**SUBJECT: SAFETY RECALL NOTIFICATION**

# SAFETY RECALL

Sr05-14A

DATE : November 2005	SECTION : 06
SUBJECT : NEW MULTIPLEX SOFTWARE PROGRAM AND INSTALLATION OF NEW WIPER HARNESS

FIGURE 1: CABLE ROUTING

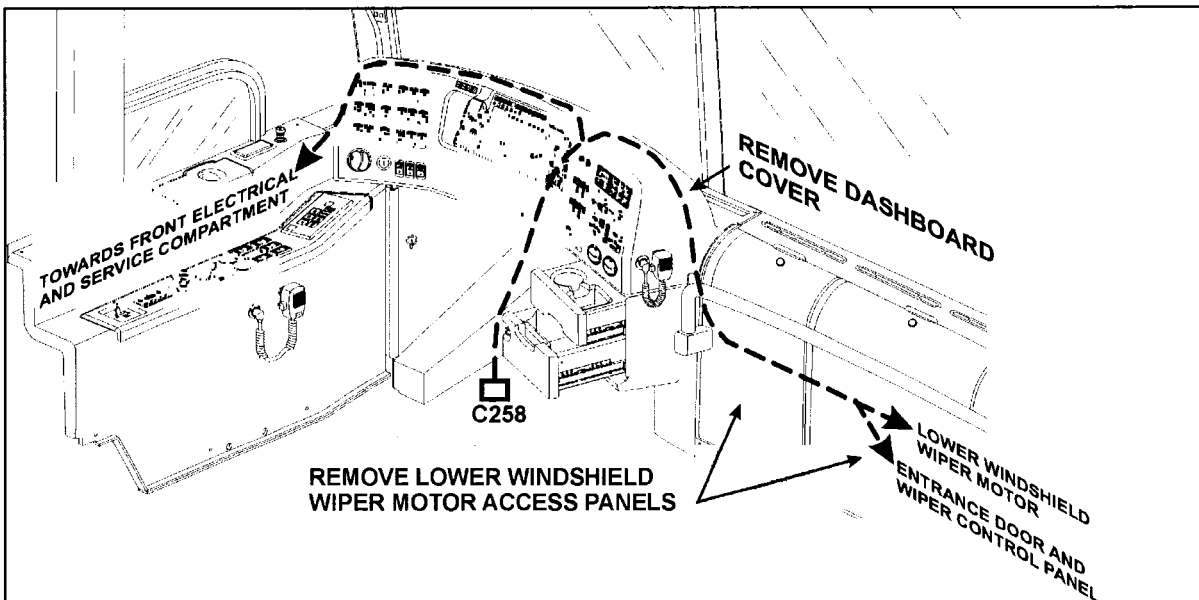
1. Remove dashboard cover and lower windshield wiper motor access panels (Refer to figure 1).

2. Disconnect connector C258 located at the base of steering column. Connect connector C258 of the new harness (066734) with cable coming from steering column multifunction lever.
3. Route cable end labeled "wipers" through inside of the dashboard and behind the driver's HVAC unit, towards the lower windshield wiper motor and the entrance door and wiper control panel; route the other end towards the front electrical and service compartment. Make sure the harness is properly secured using nylon ties by following the necessary precautions (Refer to figure 1).

**FIGURE 2: FRONT ELECTRICAL AND SERVICE COMPARTMENT**

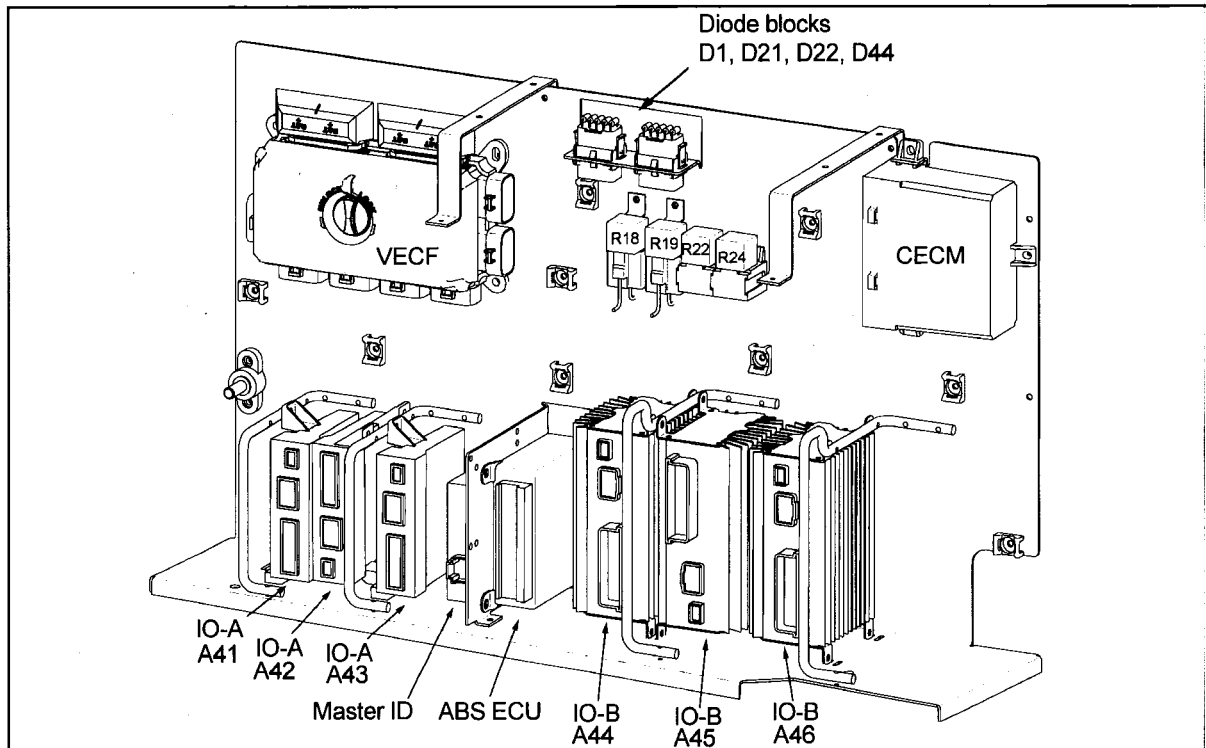
- Cut heat shrink tubing up (561918) into five 2.5-inch long pieces;
- Inside front electrical and service compartment, solder wire 24V17 of the new harness with wire 24V17 of RED connector VECF2-F; cover solder with heat shrink tubing;

- Connect wire 64A of the new harness into connector J1, socket number 5 of module A43;
- Remove wire 64A from connector J1, socket number 20 of module A43 then cover wire end with heat shrink tubing;

- Remove wire 59 from connector J1, socket number 8 of module A43 and cover wire end with heat shrink tubing, connect wire 59 of the new harness into connector J1, socket number 8 of module A43;
- Connect wire 53D of the new harness into connector J1, socket number 9 of module A44;
- Remove wire 53D from connector J1, socket number 9 of module A46 and cover wire end with heat shrink tubing;

- Connect wire 53C of the new harness into connector J1, socket number 4 of module A42. It is possible that wire 92 be already inserted into this socket, if this is the case; connect wire 92 into connector J1, socket number 2 of module A42 before inserting wire 53C in place;
- Remove wire 53C from connector J1, socket number 8 of module A42 then cover wire end with heat shrink tubing.

FIGURE 3: ENTRANCE DOOR AND WIPER CONTROL PANEL

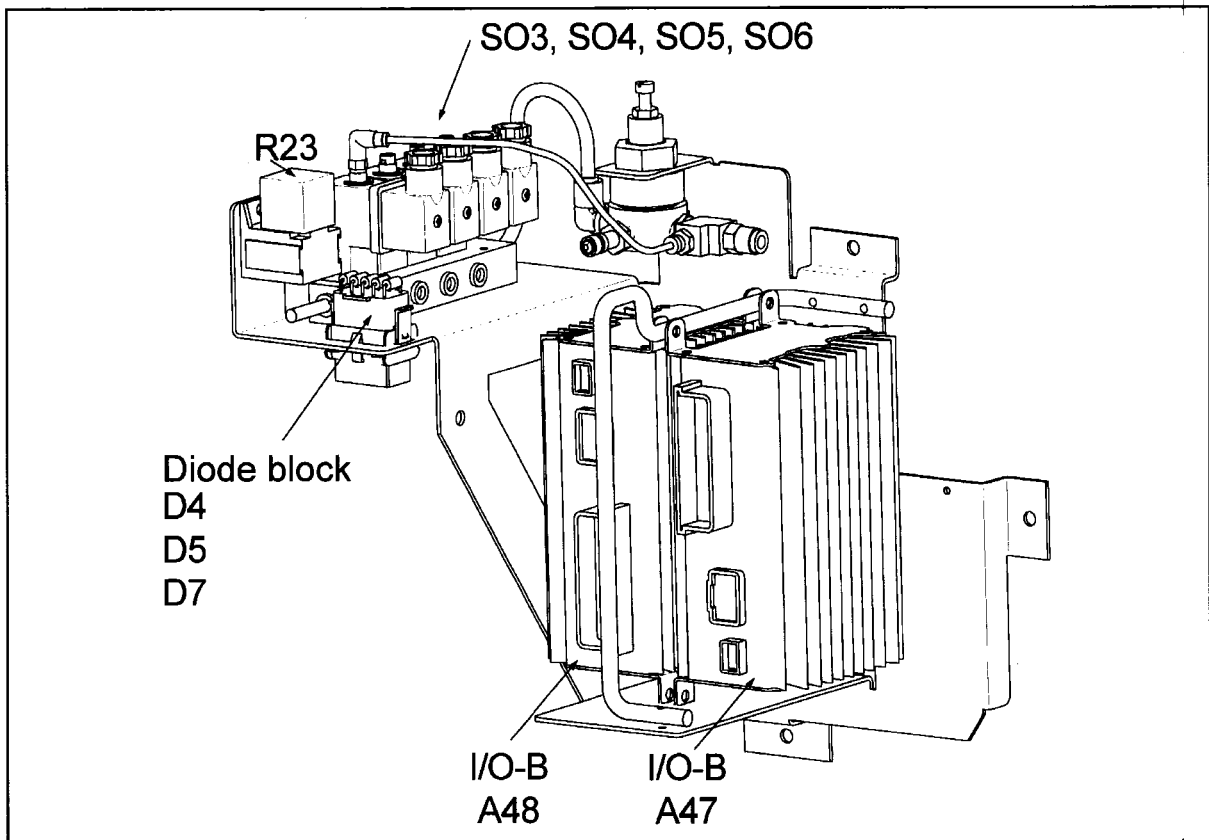
- Remove wire 53B from connector J1, socket number 4 of module A47 and insert into butt splice (562935); insert wire 53B of the new harness into the other end of the butt splice, crimp and heat both ends.
- Remove wire 53G from socket number 30 of relay R23, and insert into butt splice (562935); insert wire 53 of the new harness into the other end of the butt splice, crimp and heat both ends.
- Insert wire 31B of the new harness into socket number 30 of relay R23.

FIGURE 4: CABLE 066734

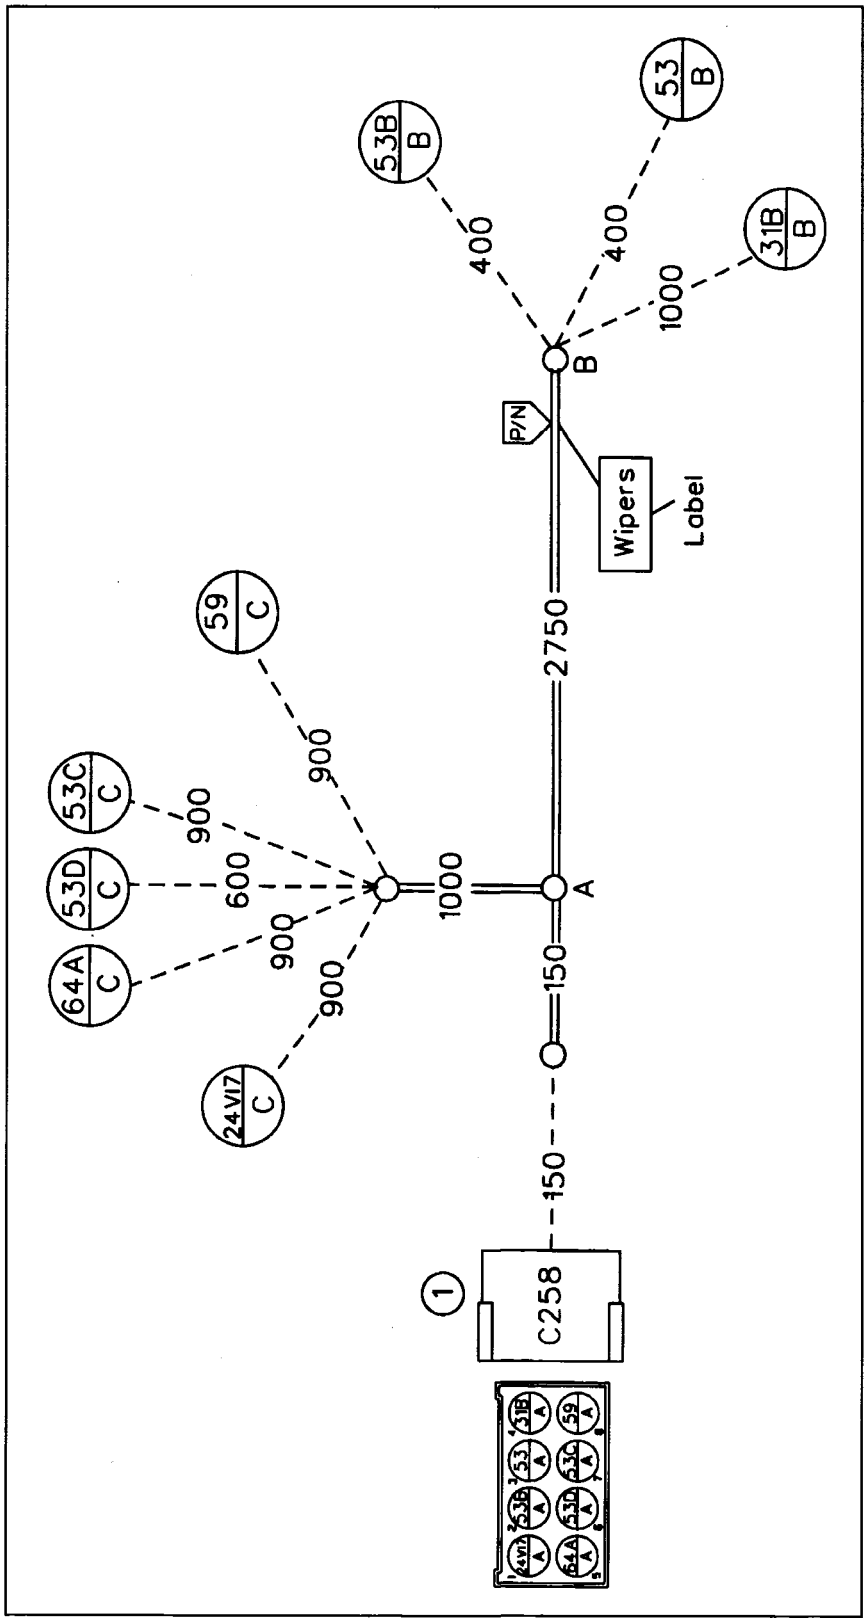
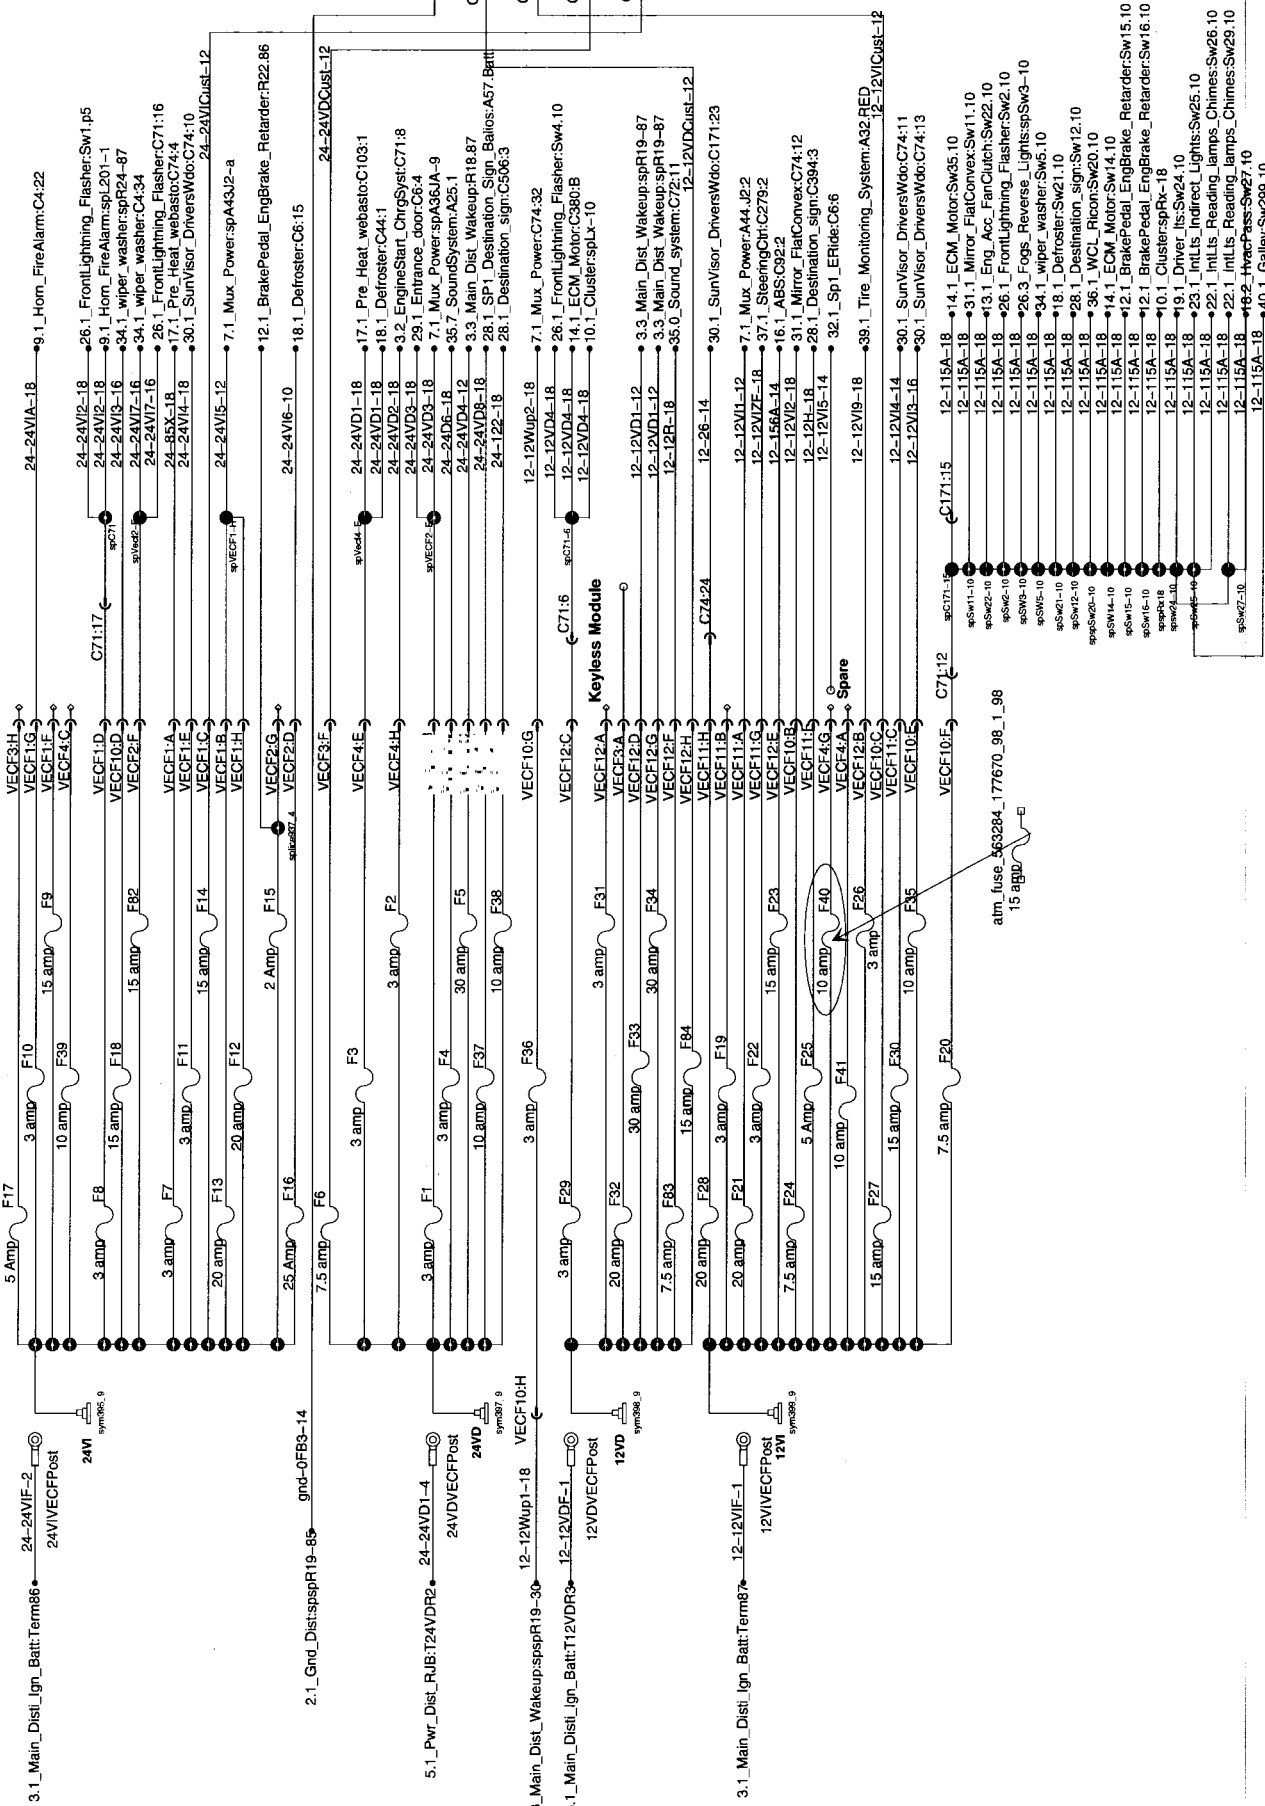
Part No.	Description	Qty
066734	Harness, Wiper retrofit	1
562935	Butt Splice	2
561918	Tubing, Heat Shrink	1
